Agenda
Village of Arlington Heights
Design Commission
Community Room, 3rd Floor

STAFF DESIGN COMMISSION REPORT RE-REVIEW

Project Name: 915 S. Dunton Avenue
Project Address: 915 S. Dunton Avenue
Prepared By: Steve Hautzinger

DC Number: 18-024
Petitioner Name: Daniel P. Poloz
Petitioner Address: 1567 Ridge Avenue, Unit 603
Evanston, IL 60201
Original Meeting Date: April 10, 2018
Re-Review Meeting Date: April 24, 2018

① West (Front) Elevation - Proposed
1/4" = 1'-0"

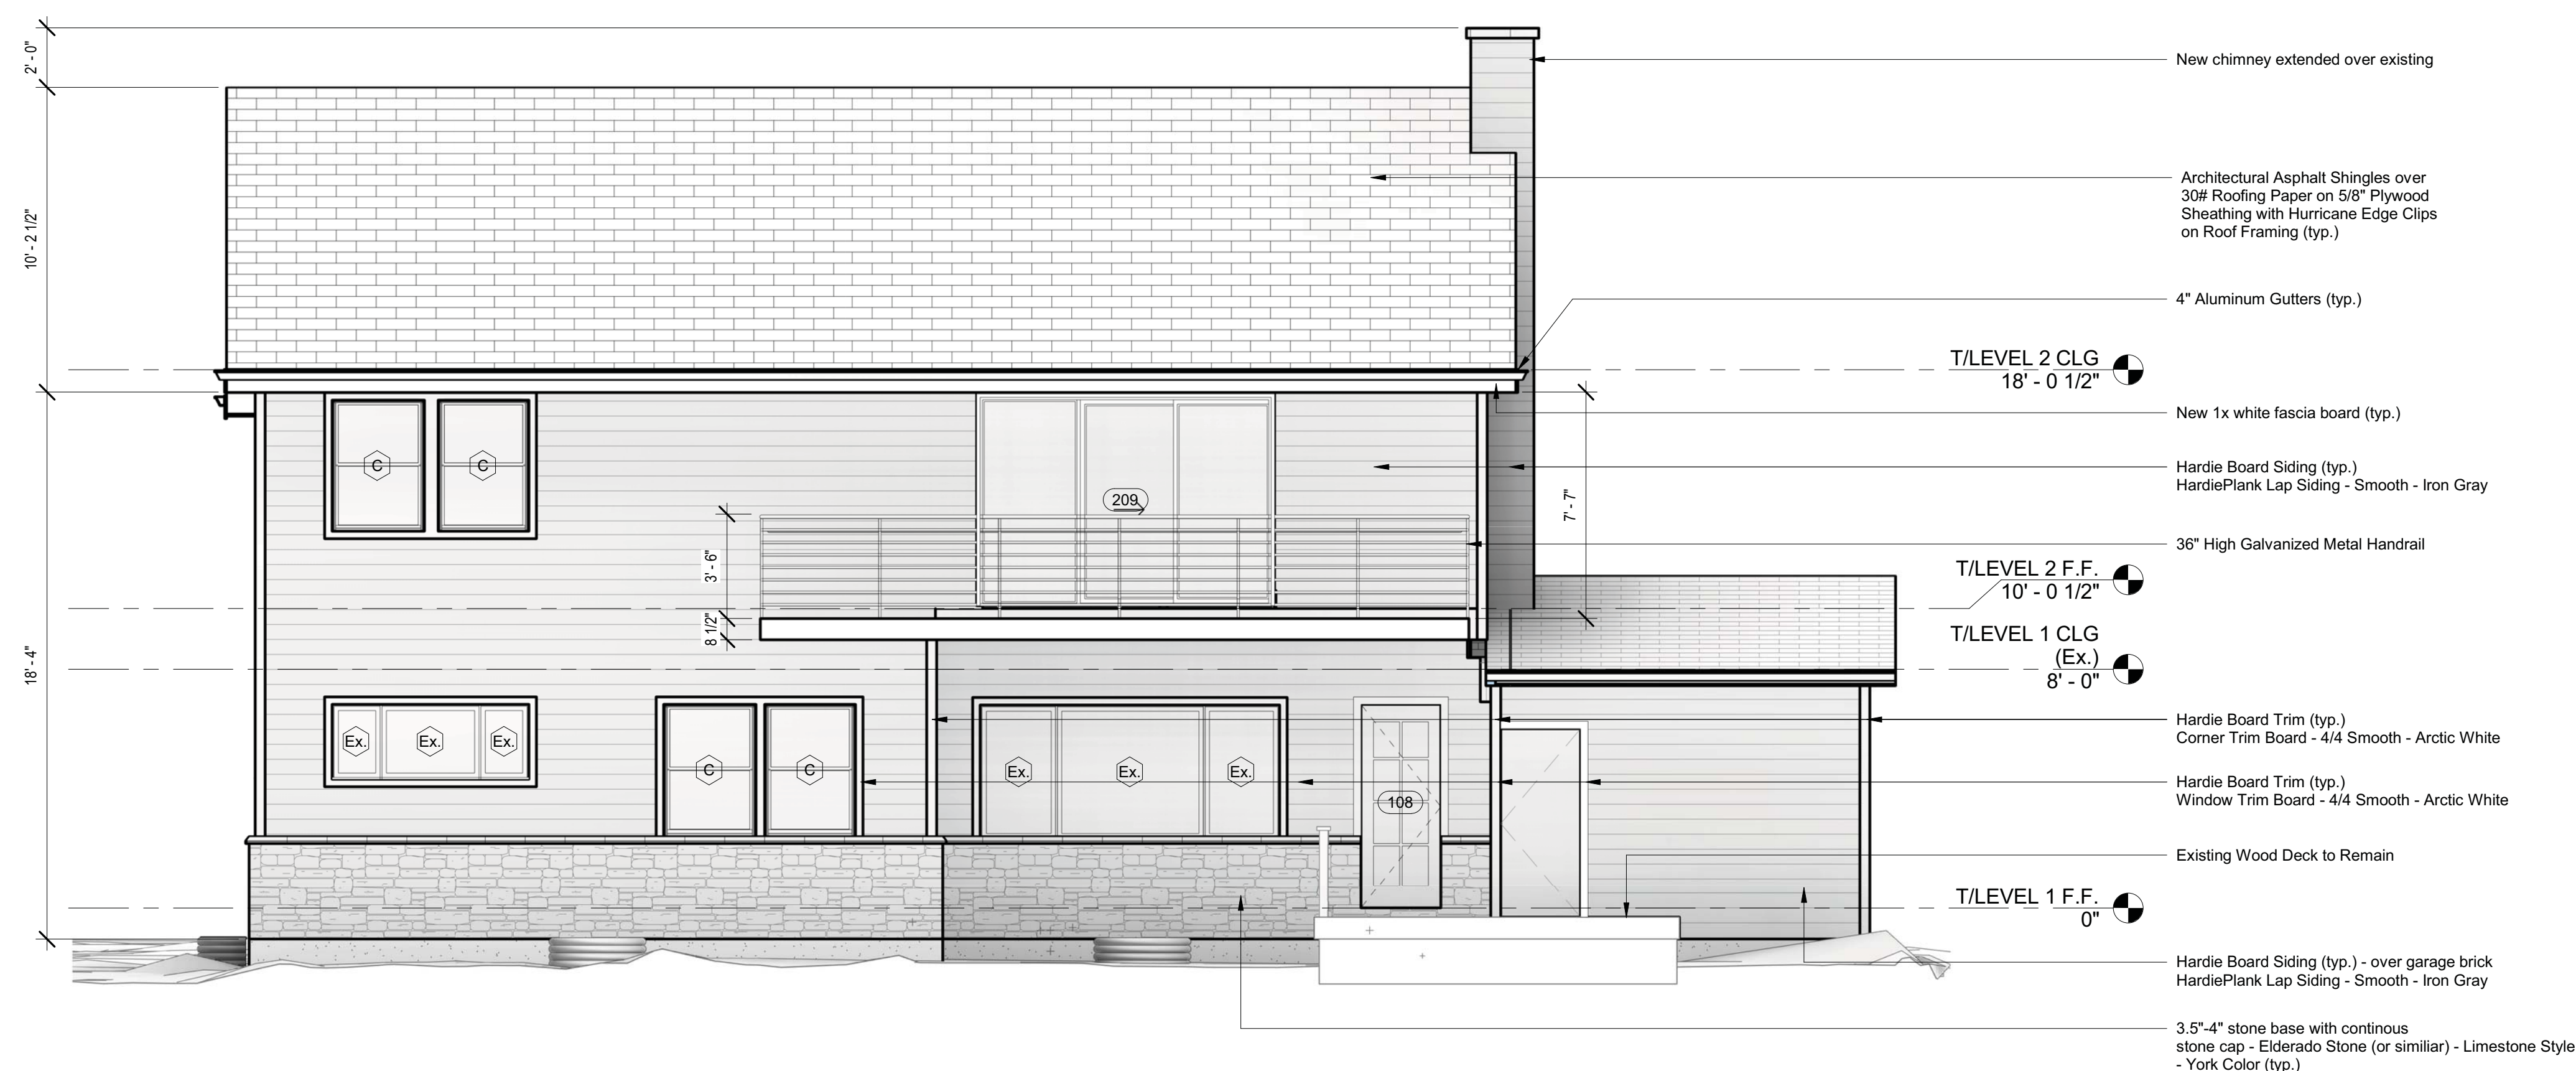
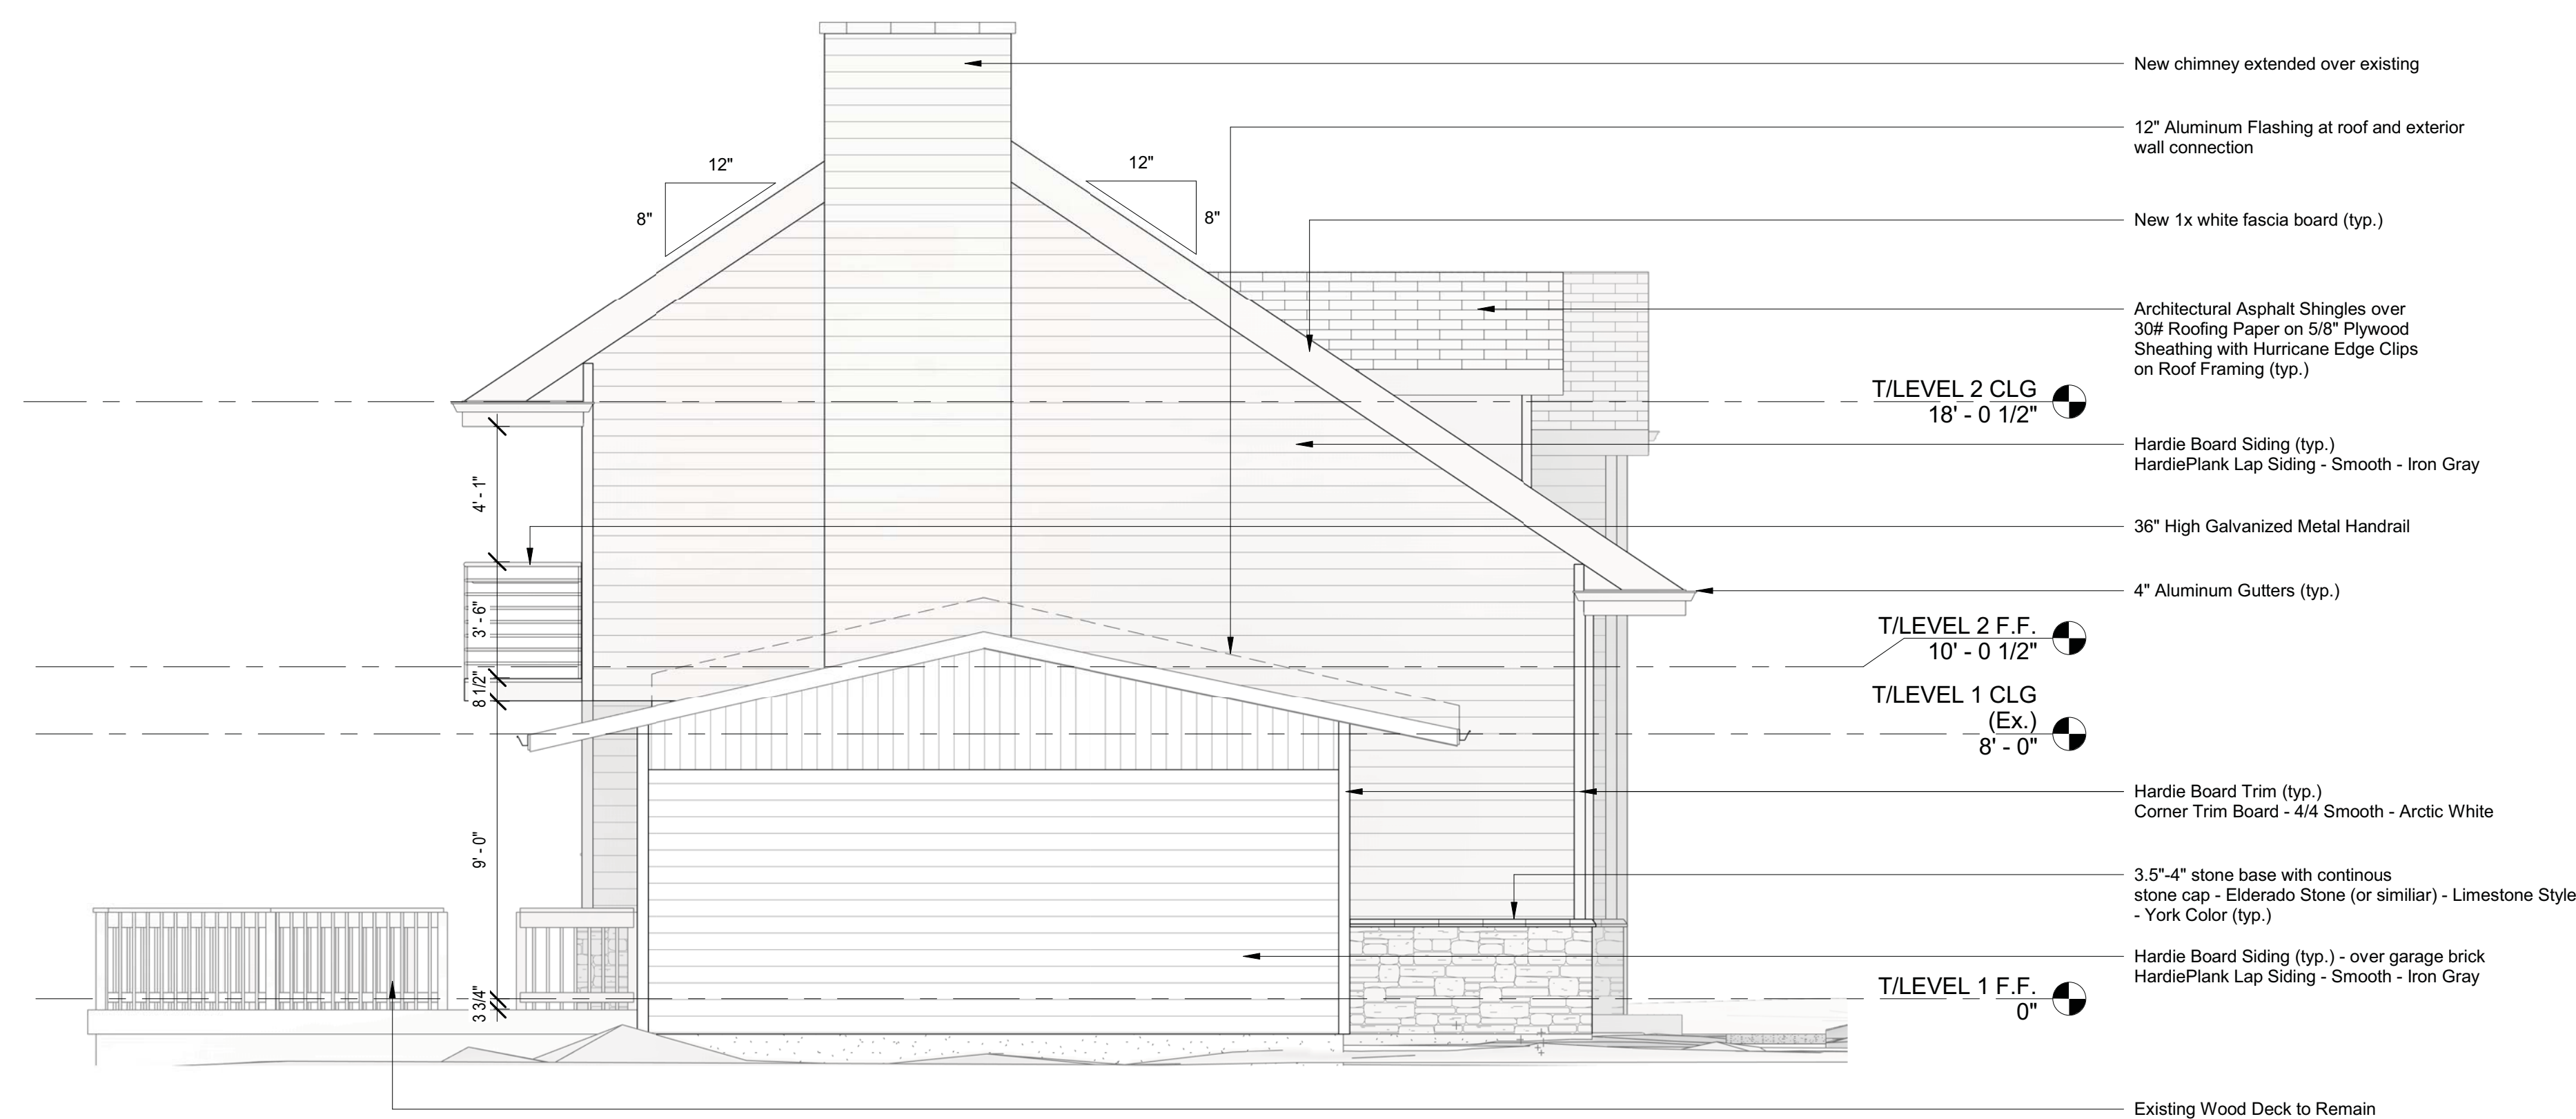
Overall, Staff feels that the revisions have addressed the primary concerns, and the revised design now has a cohesive appearance. It is recommended that the fascia and soffits on the garage be coordinated to match the detailing on the house.

It is recommended that the Design Commission approve the design for the proposed addition at 915 S. Dunton Avenue. This recommendation is based on the architectural plans dated 2/27/18 and received 3/8/18, revised exterior elevations received 4-13-18, and the following:
